## COMMUNITY DEVELOPMENT DEPARTMENT

SUBJECT: FP-2020-0013  
Apex Southeast No. 1

Final plat consisting of 77 single-family residential buildable lots, 2 commercial buildable lots and 13 common lots on 41.63 acres of land in the R-8 and C-C zoning districts.

B. Final Plat (dated: 10/30/20)

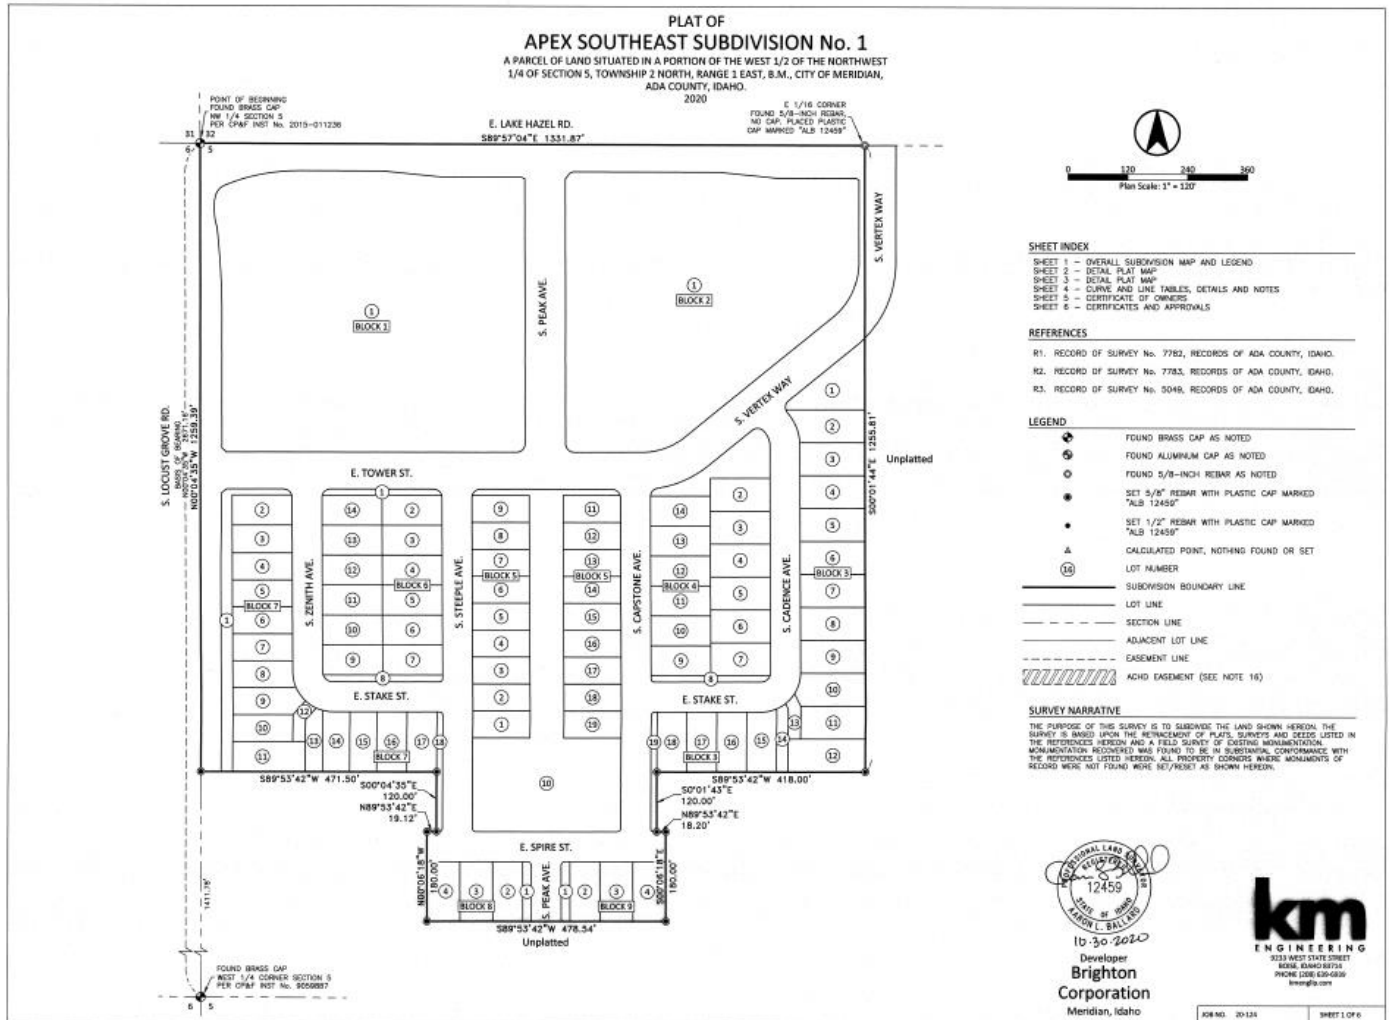
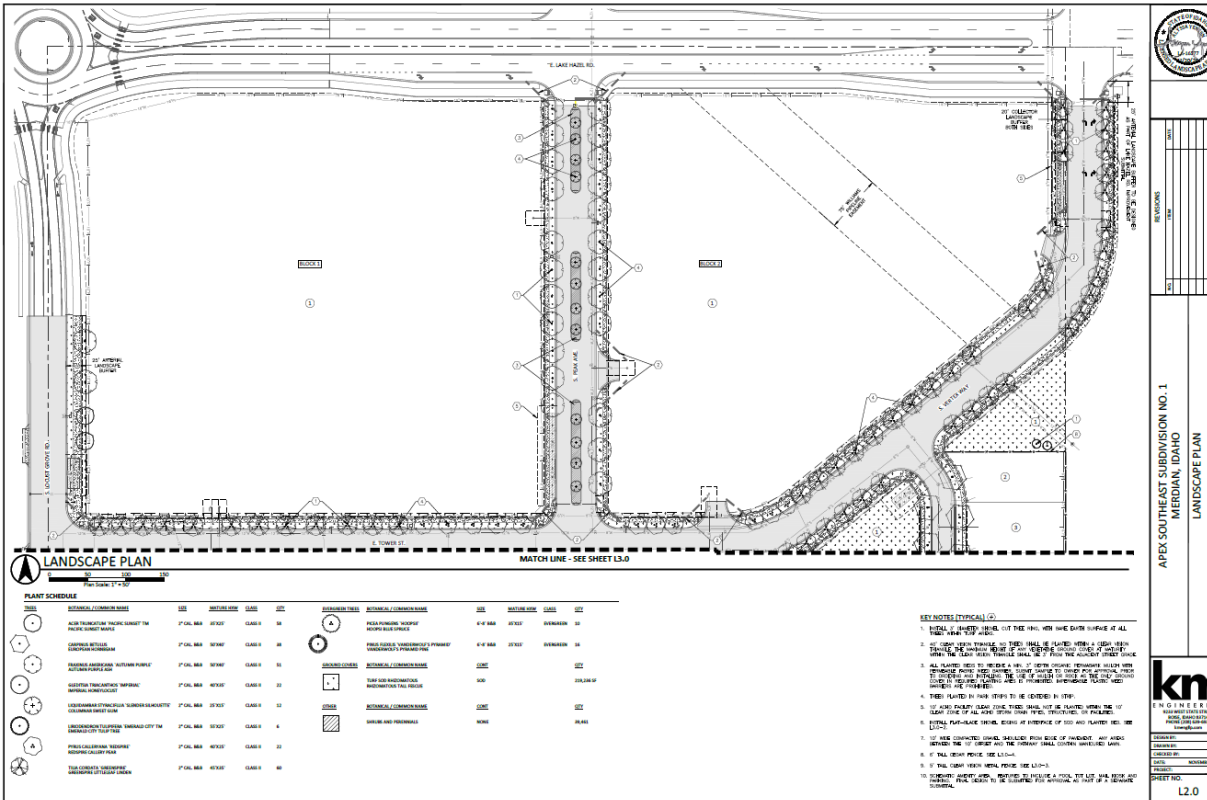
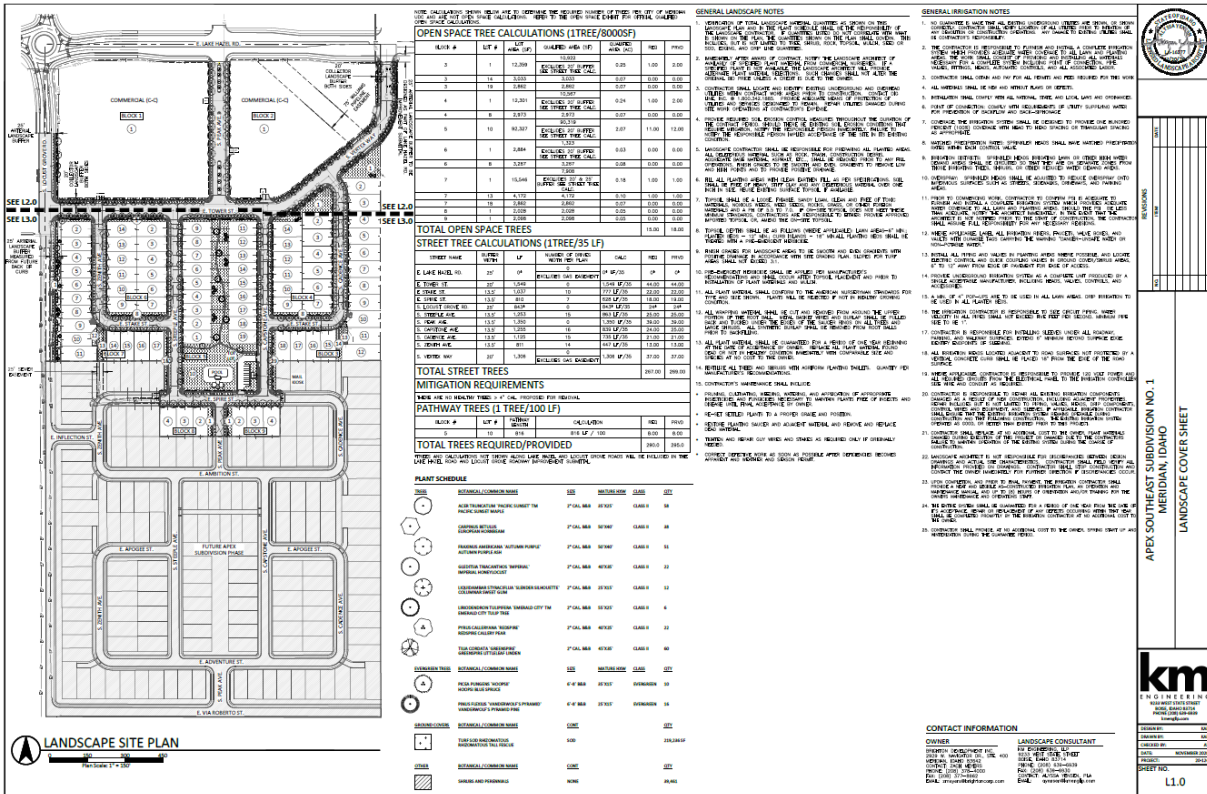
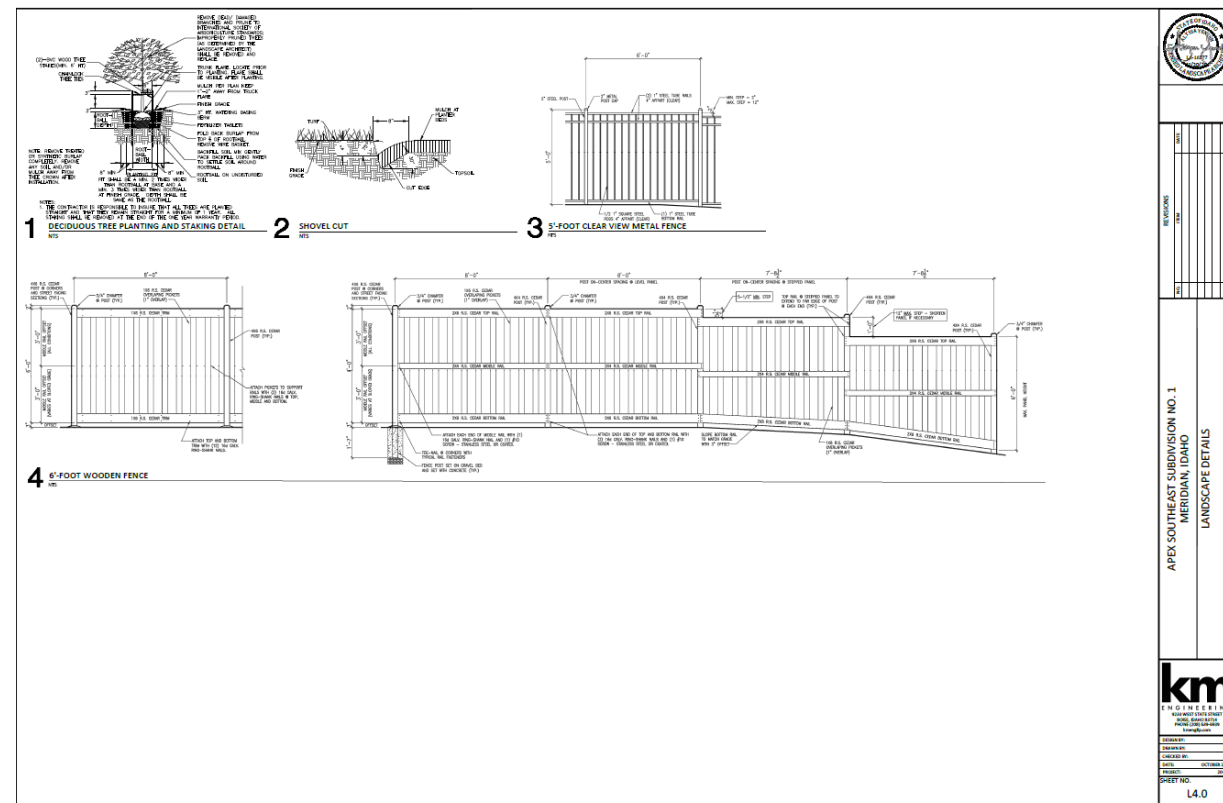
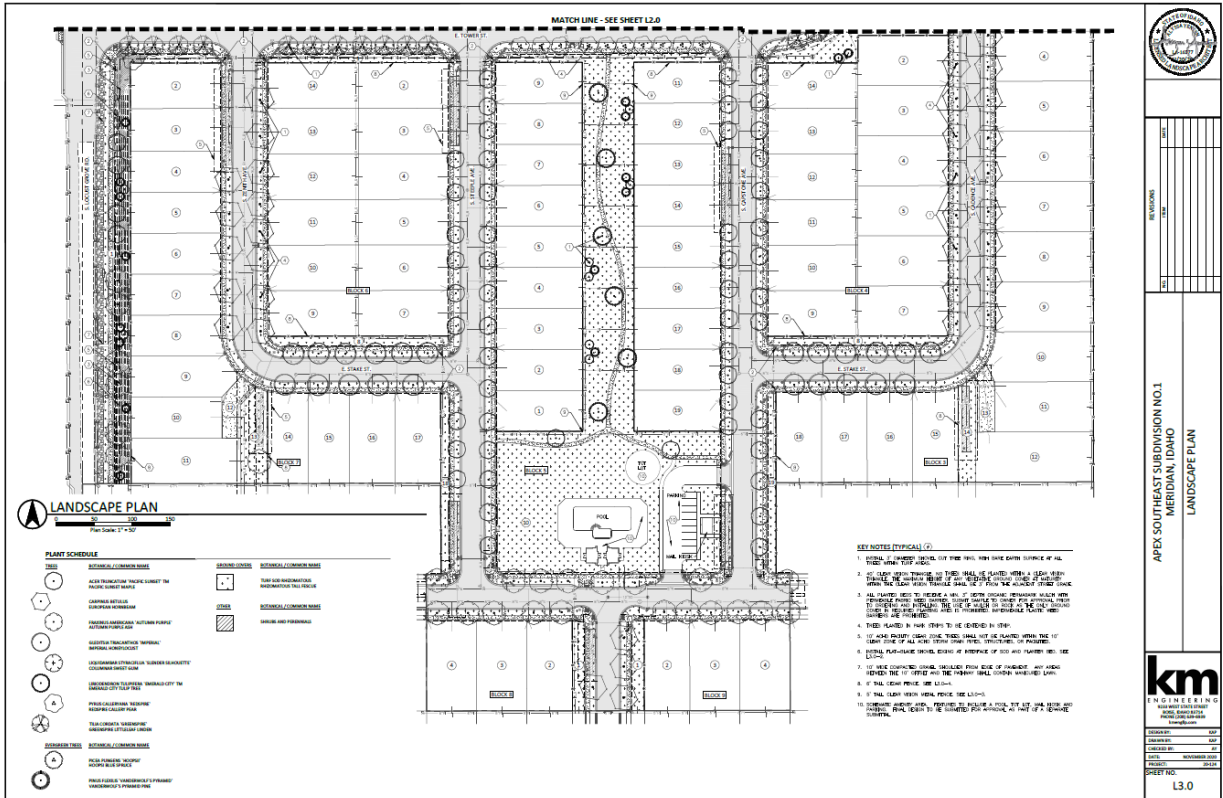
3. Prior to submittal for the City Engineer's signature, have the Certificate of Owners and the accompanying acknowledgement signed and notarized.
4. The final plat prepared by KM Engineering stamped by Aaron L. Ballard, dated: 10/30/2020, included in Section V.B shall be revised as follows:

- a. Replace S. Vertex Way with S. Bloomerang Way with change from E. Tower St. occurring at S. Cadence Ave. intersection, consistent with Ada County Street Name Review approval.

- b. Include the recorded instrument number of the City of Meridian sewer and water easement on the face of the plat on Sheets 2 and 3.
  - c. Note #5: "Lots 1, 14 and 19, Block 3, Lots ~~4 and 1~~ 1 and 8, Block 4, Lots 1 and 8, Block 6, Lots 1, 13, and 18, Block 7, Lot 1, Block 8, Lot 1, Block 9 and Lot ~~5~~ 10, Block ~~4~~ 5, are designated as common lots. . ."

- d. Note #6: "Lot 12, Block 7, and Lot 13, Block ~~13~~ are subject to a blanket easement for common drives to provide access for Lots ~~9, 10, and 11, and 13~~, Block 7, and Lots ~~10, 11, and 12, and 14~~, Block ~~13~~, respectively. Said Lot 12, Block 7 and Lot 13, Block ~~13~~ shall be owned by the Apex Southeast. . . Said Lot 12, Block 7 and Lot 13, Block ~~13~~ are subject to blanket. . ." Include a note requiring the common driveways to be constructed of a paved surface capable of supporting fire vehicles and equipment as set forth in UDC 11-6C-3D.8 in accord with preliminary plat condition #A.8.

- e. Note #13: Include recorded instrument number for ACHD landscape license agreement.
  - f. Note #14: Include recorded instrument number for ACHD public right-of-way<sup>7</sup> easement (sidewalk).

- g. Note #16: Include all lots subject to the ACHD storm water drainage system easement.
  - h. Note #20: Include E. Tower St. and S. Vertex Way/S. Bloomerang Way in the note.

- i. Depict a minimum 15-foot wide common lot in Block 3 for a micro-path connection to Discovery Park in the vicinity of Lots 6 and 7, Block 3 as required by the Park's Department with the preliminary plat.

### E. Common Driveway Exhibits

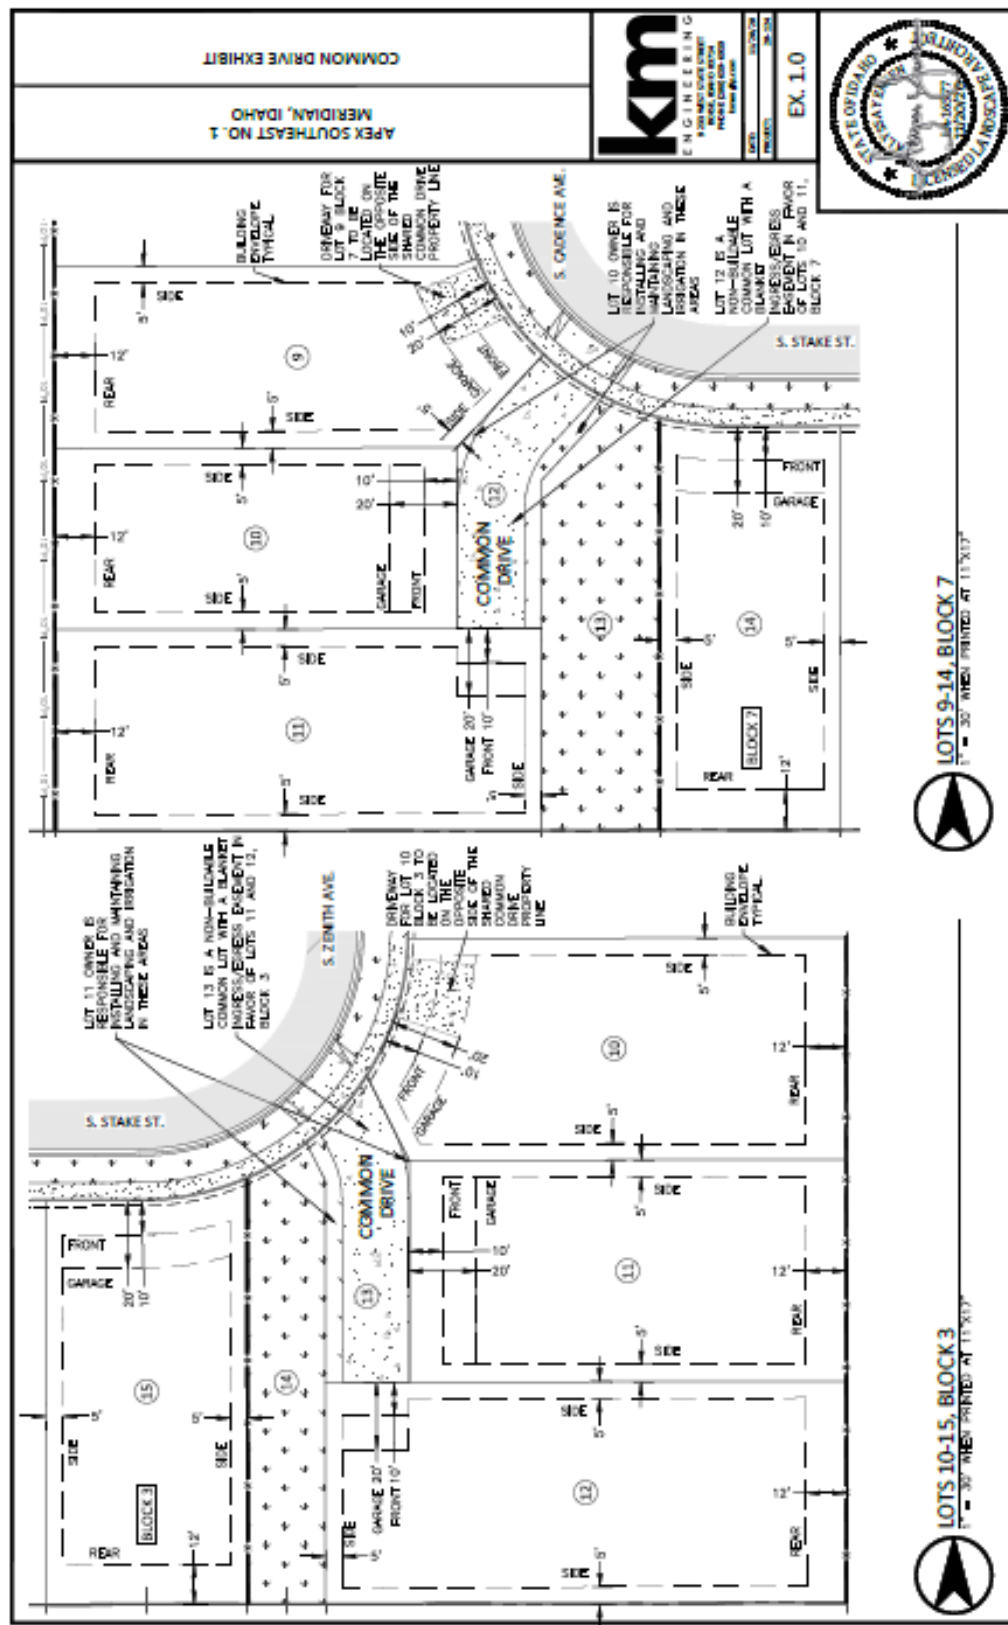
The proposed emergency access exhibit in Section VIII.F has been approved by the Fire Dept.
